***MODIFICATION REQUEST:
Thomas Street Car Park, Chatswood
MP09_0066 MOD 6
Increase in the height of the buildings,
floor space, and car parking including
above ground car parking.***

Director-General's
Environmental Assessment Report
Section 75W of the
Environmental Planning and Assessment Act 1979

July 2013

Figure 11. Height study showing the Chatswood CBD with a repositioned height arc and suggested reduced building heights marked in yellow

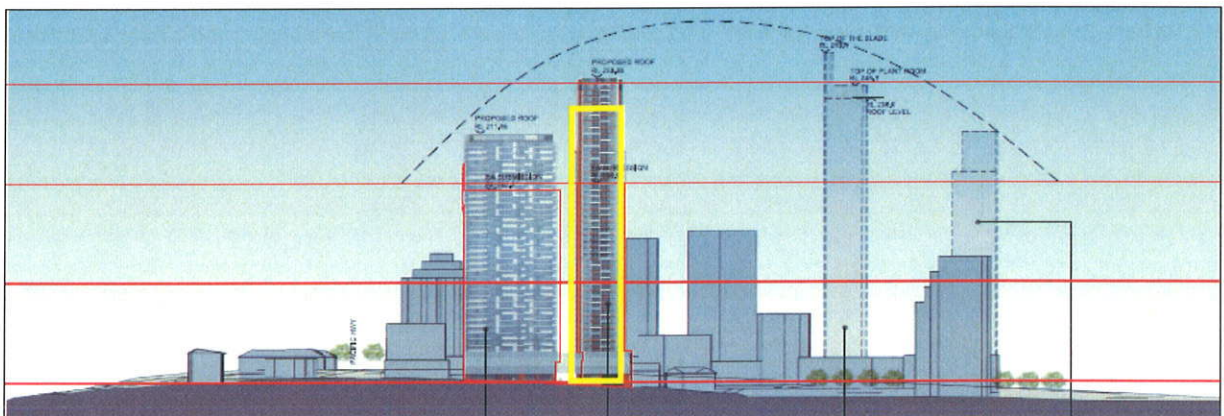
The proponent's notional arc bears little relationship to the existing skyline (apart from the CTPP Towers) or strategy for future development of the CBD. The application of this arc would infer that it is appropriate to provide taller buildings than the CTPP Towers. The Department does not consider that this is a sound planning approach and does not consider that matching the height of the tallest nearby building achieves an appropriate outcome as it does not achieve a form that emphasises the town centre of Chatswood. In urban design terms, the Department considers that it is more appropriate that the CTPP Tower, which marks the location of the transport interchange and is arguably toward centre of the CBD, should be maintained in the skyline as a higher and more dominant form.

The Department considers that a more supportable approach is to allow the CTPP tower to read as the tallest building in the CBD, and for new towers to step down from this level in order to achieve a better tower height distribution for the CBD skyline. With this approach, the Department considers that a better urban form is achieved by reducing the height of the proposed residential tower to a height midway between the height of the serviced apartment tower and the top floor of the CTPP project. This would result in a reduction of height of Building 1 by approximately five storeys (marked in yellow on **Figure 11**). This will reduce the gross floor area by 3,830m² and the total number of apartments by 40.

Conditions of approval are recommended to achieve a reduction in the height of the proposed residential tower (Building 1) by five storeys. With the imposition of this change, the Department considers that the height of the buildings would be acceptable from an urban design perspective and provide a more appropriate fit when compared to heights of other buildings within the CBD.

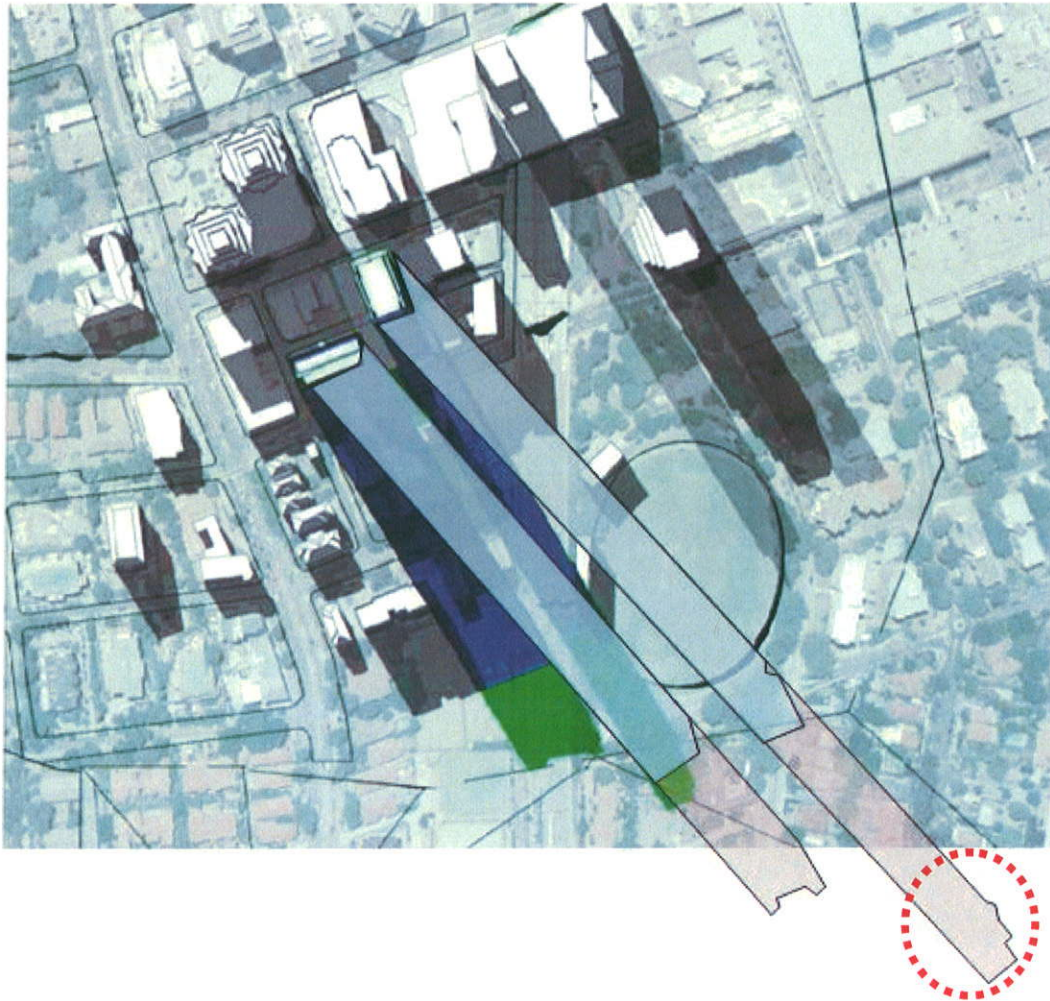
Submissions have objected to overshadowing arising out of the proposal's additional height. The proponent provided shadow diagrams in the PPR that show the extent of additional overshadowing.

In summary the Department considers that the proposed additional building height will have a minor impact to nearby open space areas (when considered against the impacts from the existing approved development). This additional impact is considered to be reasonable given that these areas will only be affect for brief periods through the day. The additional proposed building height will cast shadow toward additional residential properties, if only for very short periods though the day. The Department considers that the impacts of the additional shadowing would be mitigated by the recommended 5 storey reduction in building height for Building 1.

Figure 14: Level 2 floor plan showing the partial sleeving of carparking in the podium with apartments. The dotted circle highlights the single parking space that the Department considers should be replaced by active apartment uses on all podium levels.

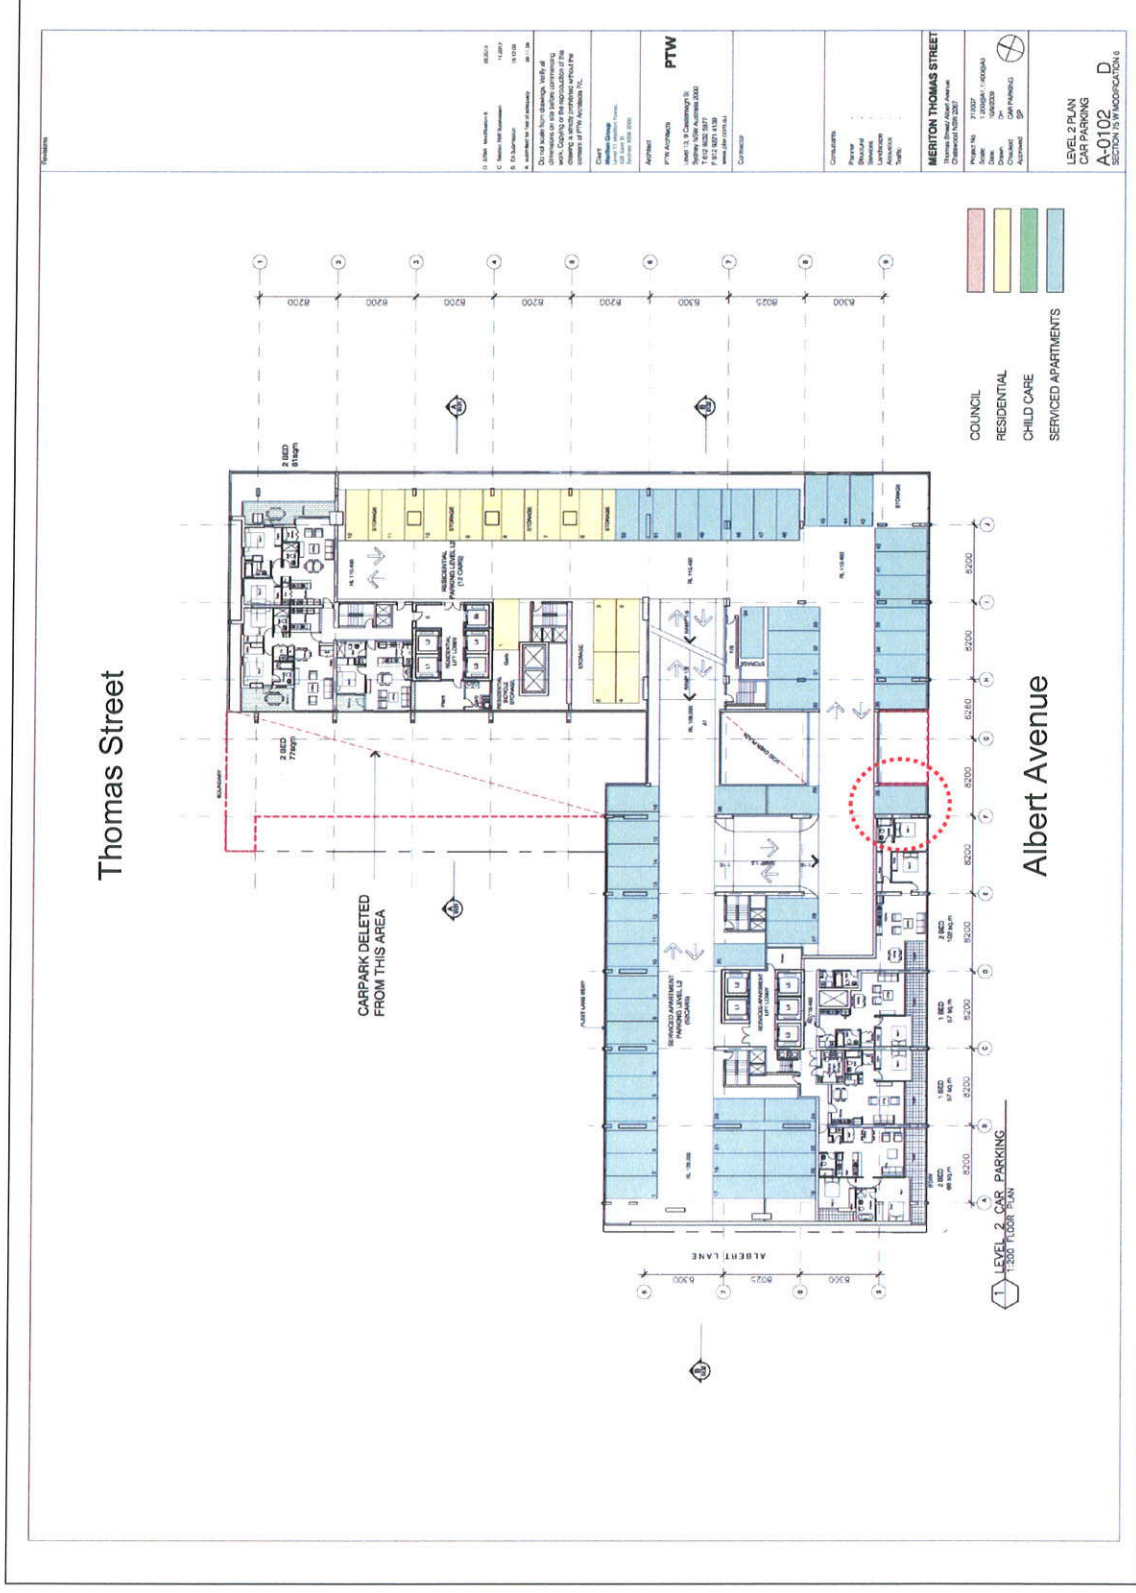
In relation to the major street frontages, the Department notes that the sleeving of above ground car parking with residential uses concentrated to the two lower levels above ground provides an acceptable degree of podium activation at these levels. The Department notes that other parts of the facade containing carparking are proposed to be patterned with a facade that approximates the serviced apartment façade below in terms of materials, depth and composition. This is shown on the elevations and illustrated in **Figure 13**.

The Department considers that the podium should be better activated, in order to improve the streetscape impacts along the major street frontages. The Department considers that the design approach of sleeving carparking with residential uses as used on Levels 1 and 2 should also be applied to Level 3. This will help to improve the level of activation on both major street frontages. The Department's proposed amendments to level 3 are shown in **Figure 15**. The Department has discussed these changes with the proponent, which has not objected. The proponent has advised that this would add 6 apartments on Level 3 (comprising of 3 x 1 Bedroom and 3 x 2 Bedroom) totalling 462 square metres of gross floor area.

Conditions of approval regarding these design amendments are recommended.

Figure 15: Level 3 floor plan (podium) marked up to show the recommended areas for increasing activation (see Section 5.2) and reducing carparking (see Section 5.3).

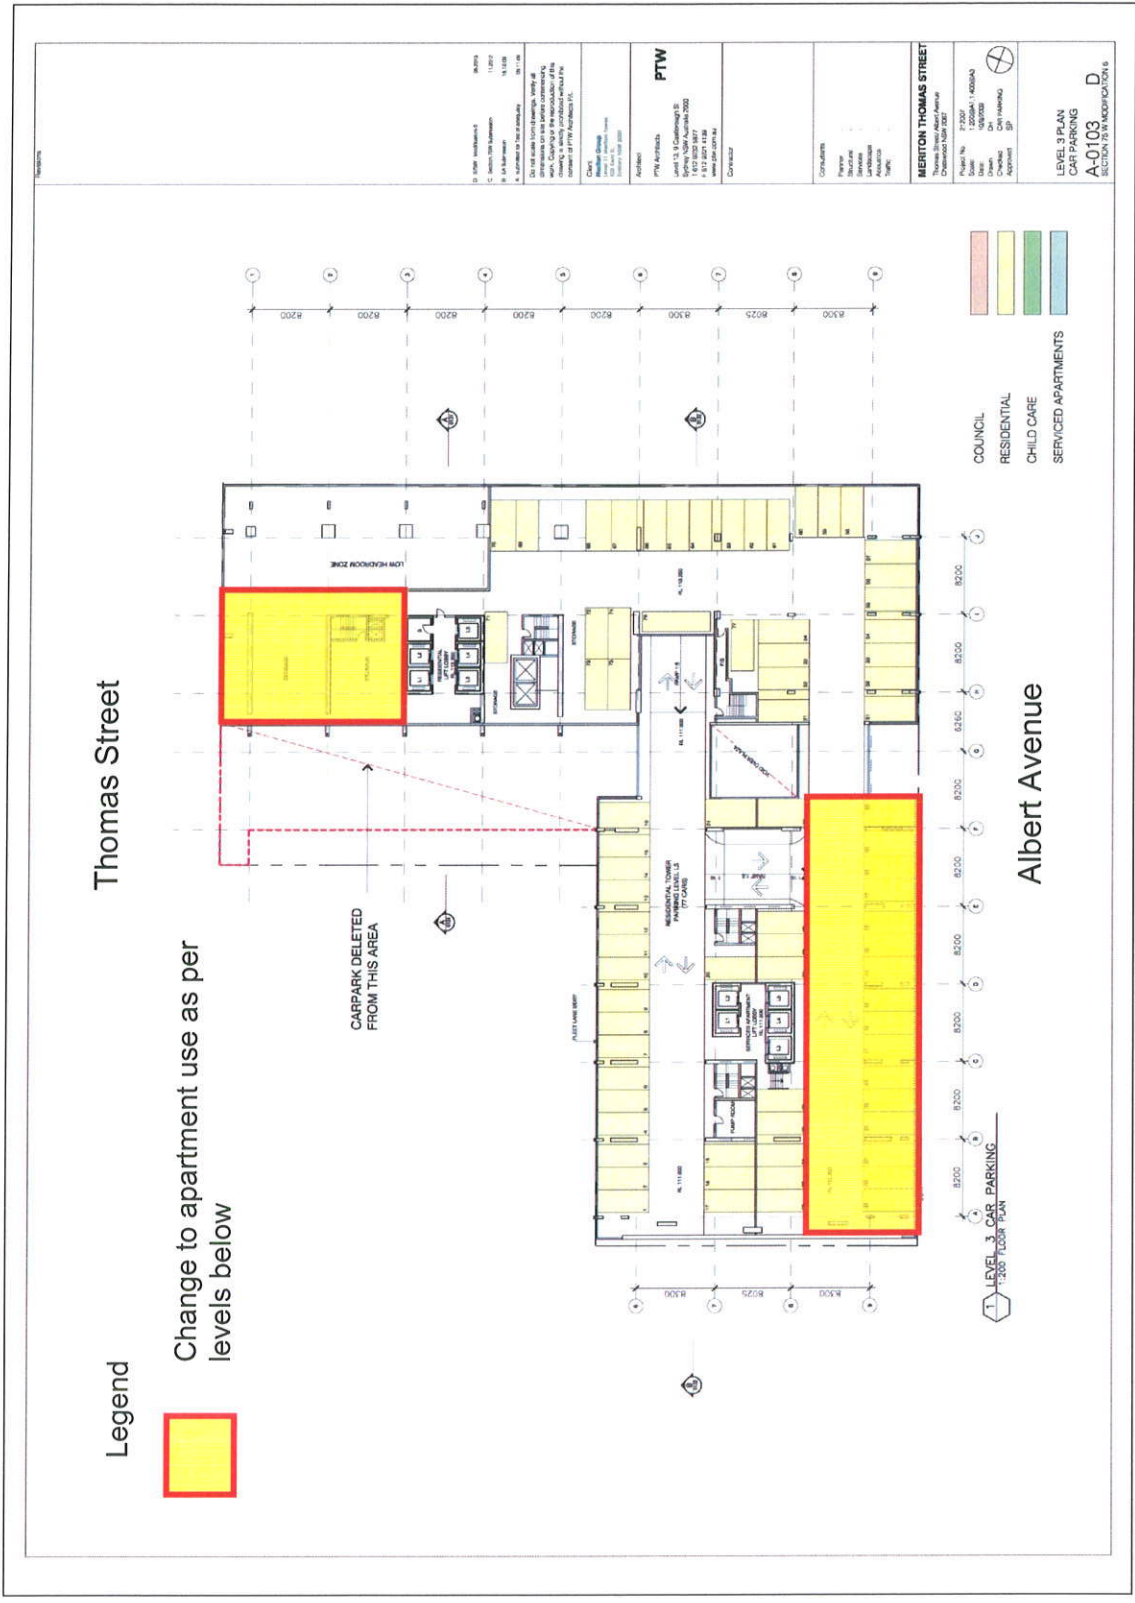
The Department also considers that the single parking space on Levels 1, 2 and 3 on the corner of the through site link and the Albert Avenue frontage adjacent to the through site link (see the highlighted space on **Figure 14**) should be replaced by apartment uses. These amendment will further improve the activation of the Albert street frontage by adding an activating use to the corner of the through site link (this will be the only activating use above ground level facing the through site on the Albert Avenue side of the podium).

Figure 16: Detail of the ground floor plan showing the driveways adjacent to the northern and southern boundaries, circled in red (from the PPR).

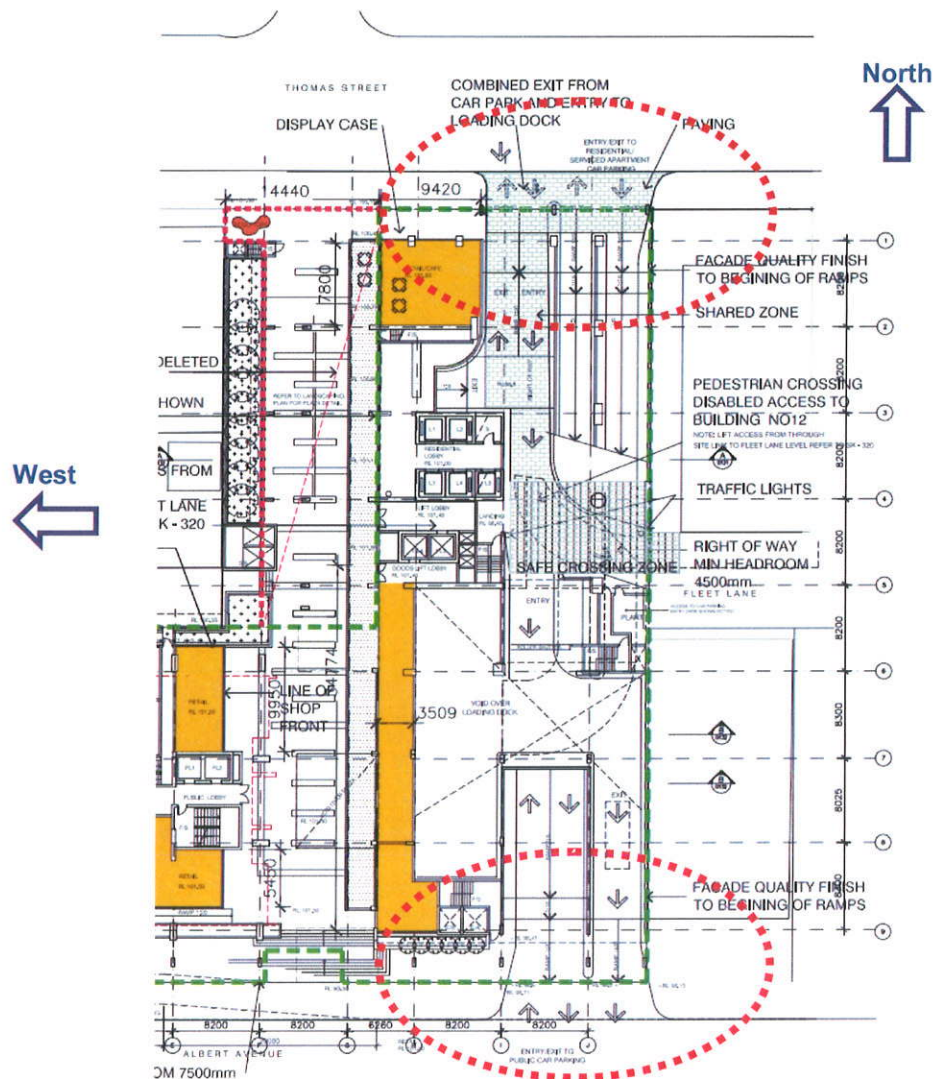
The development as approved includes one combined vehicle entry/exit on Albert Avenue approximately 9.5 metres wide and a combined right of way entry and carpark exit on Thomas Street approximately 9.5 metres wide. The right of way also exits into Fleet Lane (east). This is shown in **Figure 16**.

The proposed modification includes additional vehicle entry/exit points compared to the current approval. The total width of vehicle crossovers on Albert Avenue is increased to approximately 13 metres and on Thomas Street is increased to approximately 16 metres.

The Department notes that current adjacent uses include medical services for the disabled including eye surgery specialists and the headquarters of Guide Dogs NSW who have objected to the proposal.

The proponent revised the design to reduce the width of the driveway on Thomas Street by approximately one metre by removing the separation from the public carpark exit and the service vehicle entry. The proponent argued that no further reductions were available to reduce the driveway width due to the space required for structural columns. The proponent also stated that the change also included a separately paved shared driveway to assist drivers and pedestrians.

Figure 15: Detail of the ground floor plan A-0100 showing the proposed treatment of the right of way and safe crossing zone between the through site link and the rear of 12 Thomas Street (from the PPR). The path of travel, including a lift, described in the PPR is marked in blue.

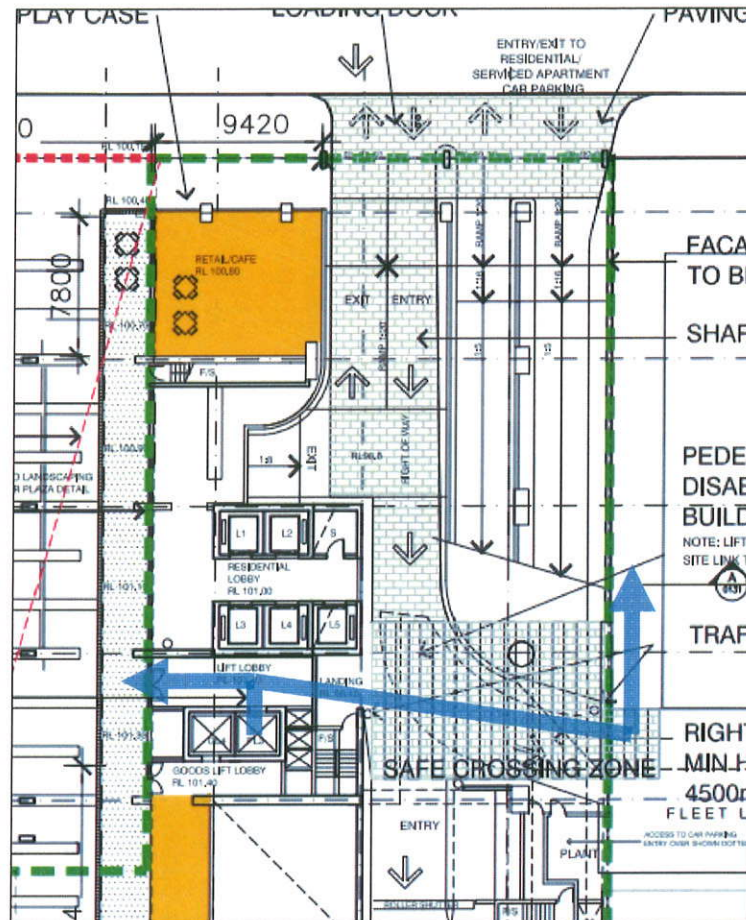
The proposed modification does not alter the Department's previous assessment of this issue which found that the reliance upon the subject site by the adjoining property for access to 12 Thomas Street is not reasonable and cannot justifiably be maintained at the expense of the development of the subject site.

Notwithstanding, the proponent has responded to this issue in the PPR by providing for an accessible path of travel between the public carpark of the proposed development and the rear access of 12 Thomas Street onto Fleet Lane. This is shown in **Figure 15**. Persons using the public carpark, or the pedestrian plaza / through site link connecting Thomas Street and Albert Avenue are able to access a lift lobby midway along the eastern side of the plaza that provides disabled vertical transport between the plaza level and the level of Fleet Lane. From there, the revised proposal includes a shared pedestrian zone treatment to the public right of way/loading dock lane which connects to Fleet Lane and the existing rear of 12 Thomas Street. From there pedestrians can access an accessible ramp along its western boundary to reach the Thomas Street entrance. The proponent argues that the treatment of this area and its generally low vehicular movements provide suitable environment to allow for its use by pedestrians including those with a disability.

The Department notes that the proposed lift access, which resolves the significant issue of vertical travel for disabled persons, along with the upgraded finishes and improved pedestrian design of the marked safe crossing zone provides for improved accessibility compared to the development as approved. The Department supports this amendment subject to the detailed design providing a suitable pedestrian environment in terms of materials, finishes and lighting. A condition of approval is recommended to ensure this outcome.
